RFP 24MCO640

**In response refer to RFP No. 24MCO640 Addendum 1
December 17, 2024**

Bidder agrees to perform all work for **2025 Midland County Pavement Maintenance Project** described in the Specifications and shown on the Plans, for the following unit prices. **The scope of work on this bid proposal includes both Single-Course and Double-Course Seal Coat and Striping. All pothole repairs would be completed by others.**

MIDLAND COUNTY, TEXAS					
2025 MIDLAND PAVEMENT MAINTENANCE PROJECT E CR 180					
DESIGN	DRAWN	DATE	PROJECT NO.	SCALE	SHEET #
J.C.T.	I.R.	11/12/24	56486	1" = 200'	C2-79.2R

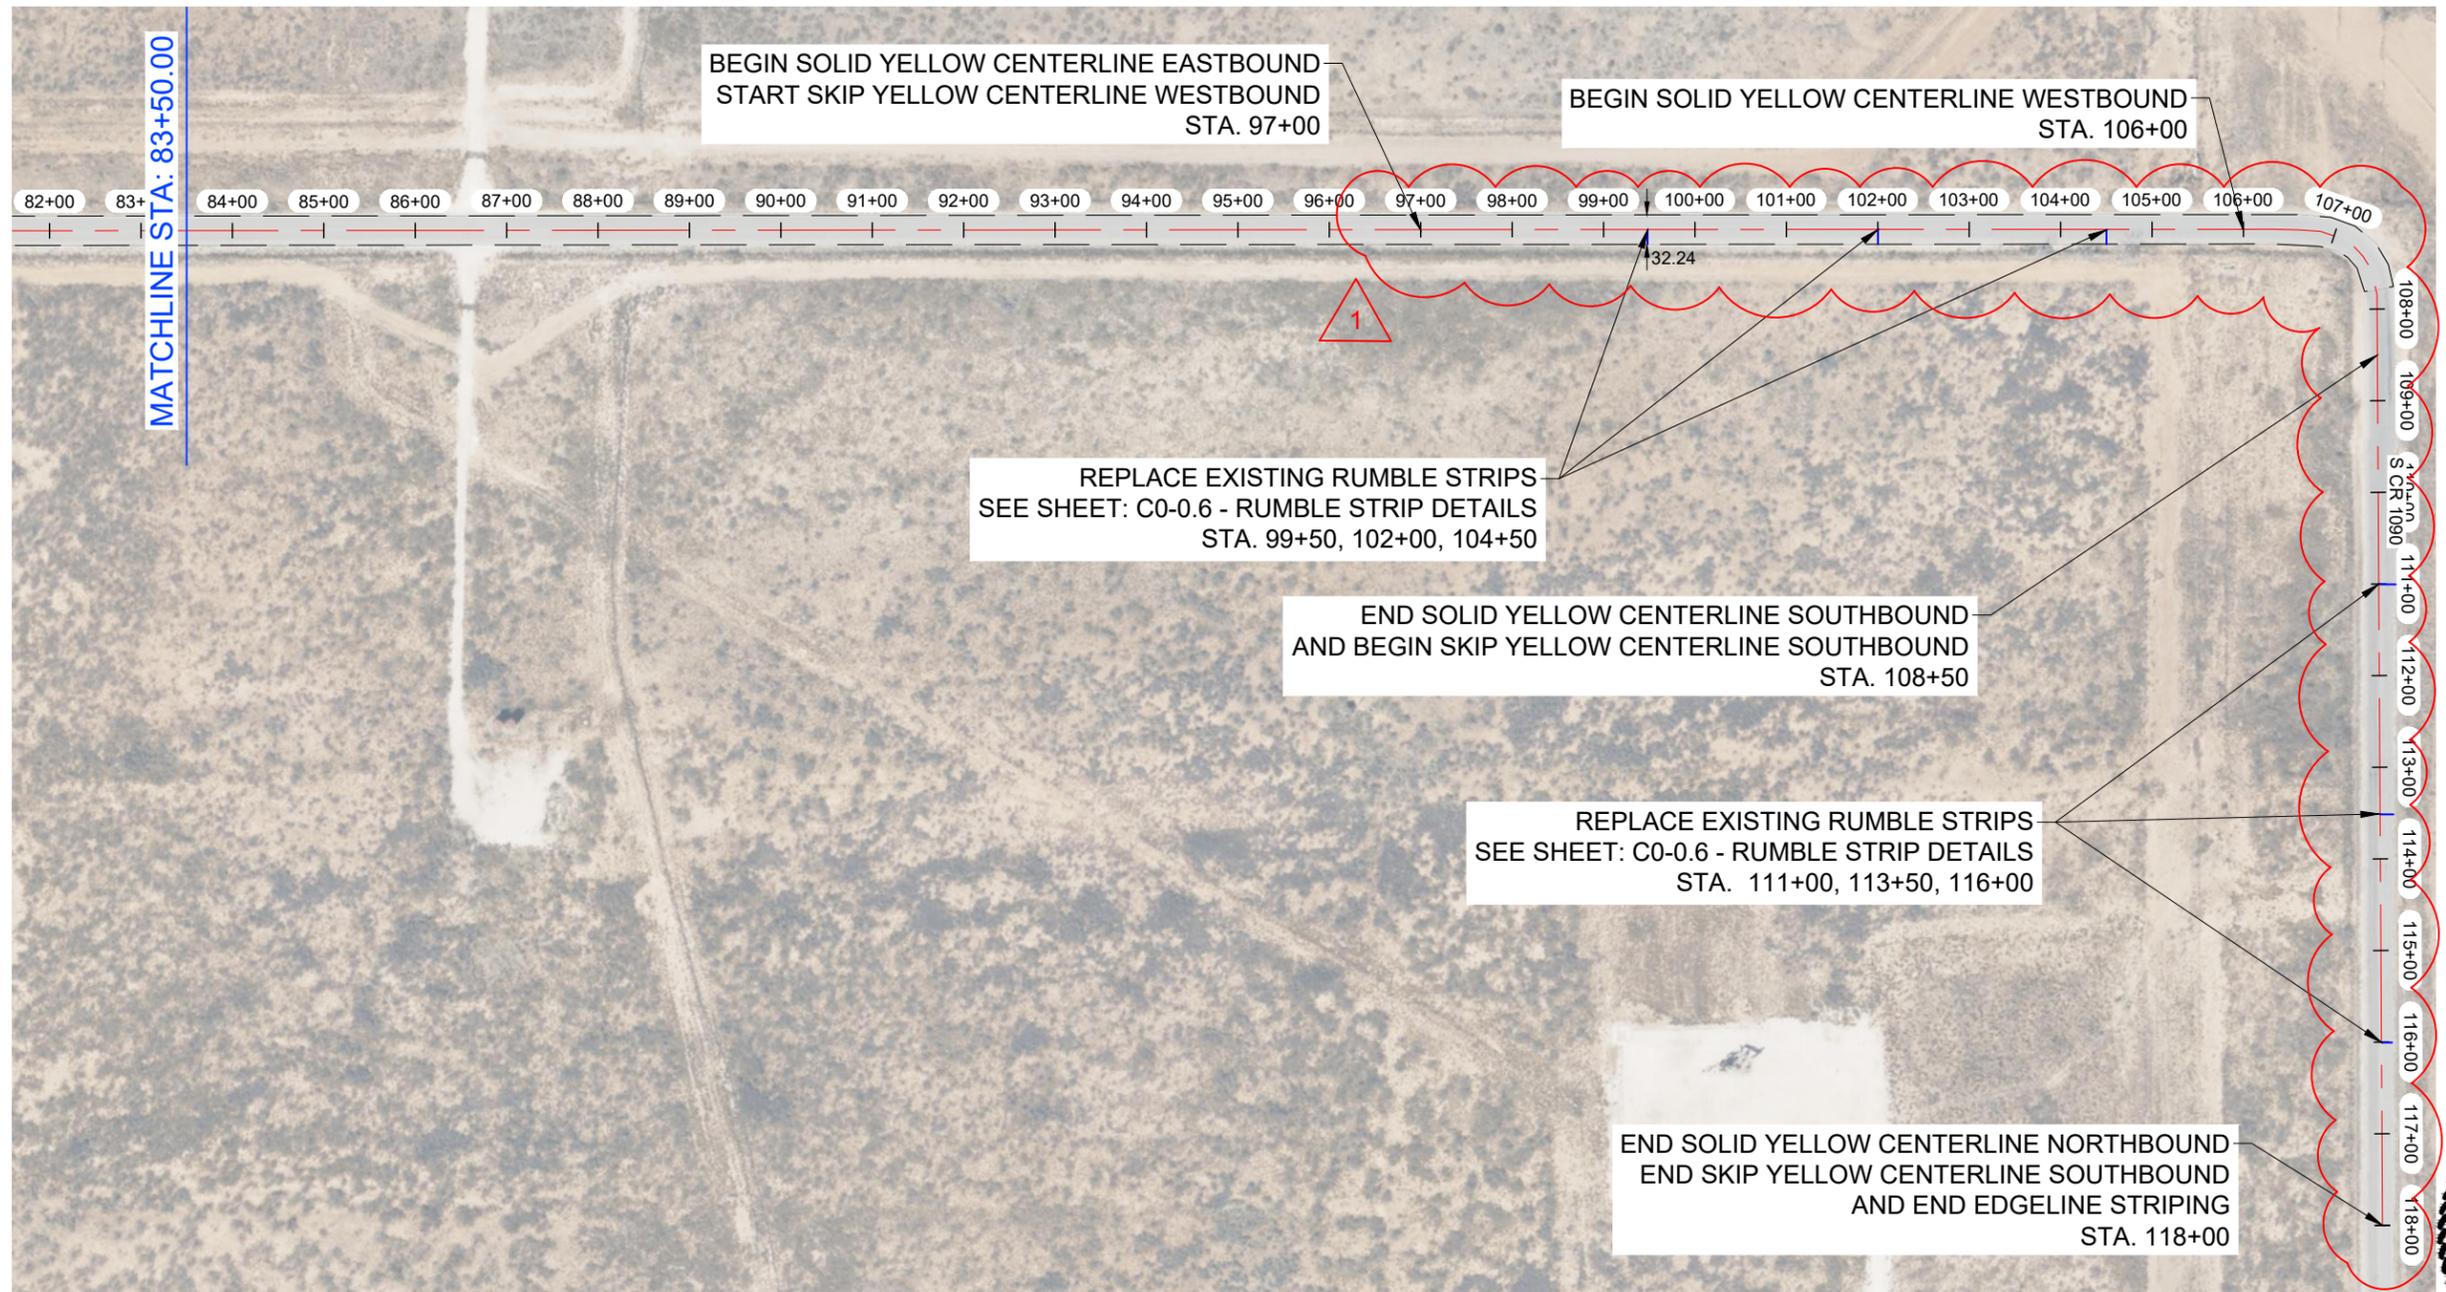
Replace Plan Sheets C2-79.0 through C2-79.2 with Plan Sheets C2-79.0R, C2-79.1R and C2-79.2R. The plan sheets were revised to include rumble strips (no separate pay) and additional striping

BEGIN SOLID YELLOW CENTERLINE EASTBOUND
START SKIP YELLOW CENTERLINE WESTBOUND
STA. 97+00

BEGIN SOLID YELLOW CENTERLINE WESTBOUND
STA. 106+00

REPLACE EXISTING RUMBLE STRIPS
SEE SHEET: C0-0.6 - RUMBLE STRIP DETAILS
STA. 99+50, 102+00, 104+50

END SOLID YELLOW CENTERLINE SOUTHBOUND
AND BEGIN SKIP YELLOW CENTERLINE SOUTHBOUND
STA. 108+50

REPLACE EXISTING RUMBLE STRIPS
SEE SHEET: C0-0.6 - RUMBLE STRIP DETAILS
STA. 111+00, 113+50, 116+00

END SOLID YELLOW CENTERLINE NORTHBOUND
END SKIP YELLOW CENTERLINE SOUTHBOUND
AND END EDGELINE STRIPING
STA. 118+00

*ADDITIONAL NOTE: NO SEPARATE PAYMENT FOR RUMBLE STRIPS. SUBSIDIARY TO STRIPING.
